TECHNICAL BULLETIN

MODEL/DERIVATIVE:
Discovery Series II (LT)
Defender (LD)

Bulletin N°: 0009
CDS. ref: L8711bu
Issue: 1
Date: 27.02.02

RADIATOR - SPECIFICATION CHANGE - TO IMPROVE DURABILITY

1

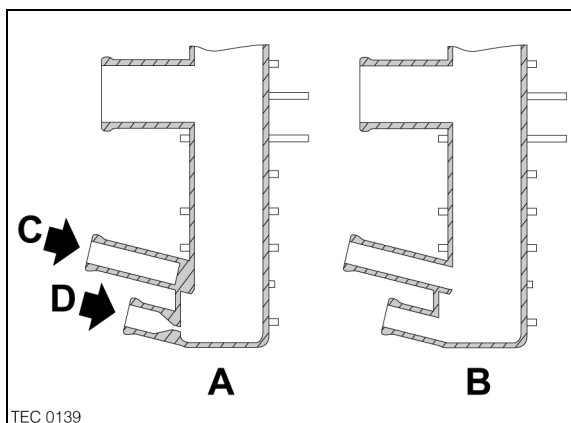
The coolant passageways in the radiator have been modified and a restrictor was introduced into the fuel cooler to improve the durability of the radiator.

NOTE: *The feed and return pipes, ('C' and 'D' in illustrations 1 and 2), to the lower section of the radiator have been modified. Do not attempt to open these coolant passageways into the radiator.*

A = The new specification radiator
B = The old specification radiator

2

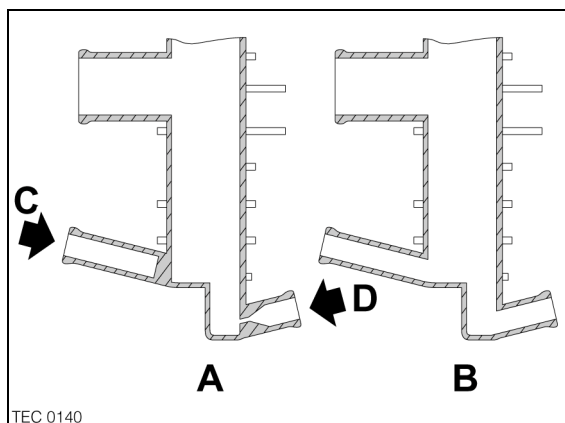
A = The new specification radiator
B = The old specification radiator

3

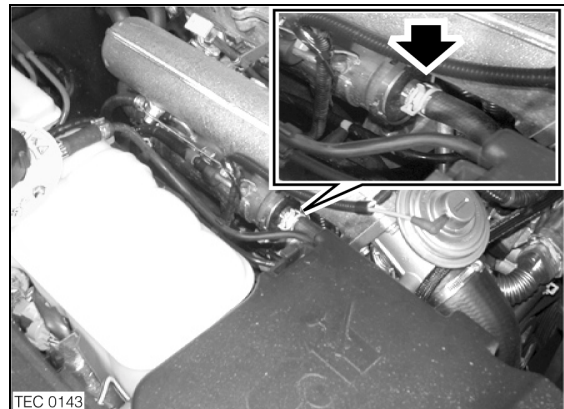
1. Position a container beneath the fuel cooler.
2. Release the clip and disconnect the coolant feed hose from fuel cooler, (inset in illustrations 3 and 4).
3. Position the coolant restrictor within the fuel cooler, (arrowed in illustration 5).
4. Connect the coolant feed hose and secure with the clip.
5. Remove the container.
6. Refill and bleed the cooling system.
7. Check the cooling system for leaks.

5

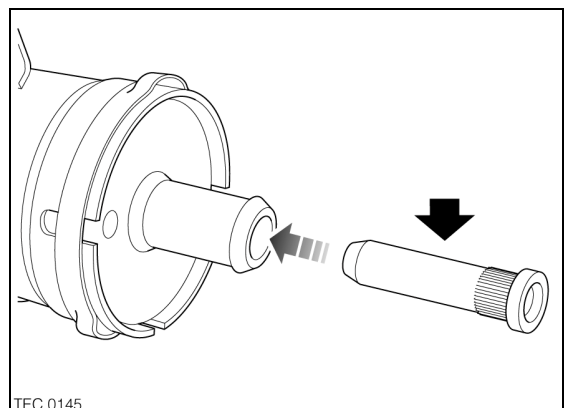
NOTE: *The restrictor has already been fitted from VIN 2A 736340 (Discovery Series II) and 2A 622424 (Defender).*
